Austausch des Abluftstutzens aus Metall gegen eine geänderte Version aus Kunststoff

Betrifft Modell: MWGD 750.0

Abluftstutzen neu ET-Nr. 545885.

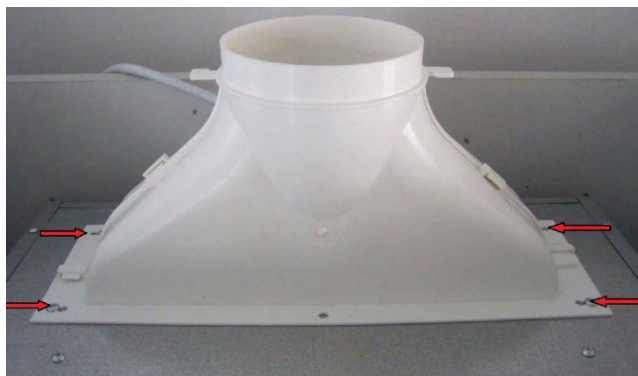
Fehlerbild:

Bei Änderung der Leistungsstufen erfolgt keine Änderung der Motordrehzahl. Das Laufgeräusch bleibt auch bei Änderung der Leistungsstufe immer gleich. Die Saugleistung ist ungenügend.

Der neue Abluftstutzen ist um 96mm höher als der alte. Abhängig von der Abluftführung ist deshalb die Montage des geänderten Stutzens nicht immer möglich.

Der Abluftstutzen aus Kunststoff wird mit vier Schrauben befestigt.
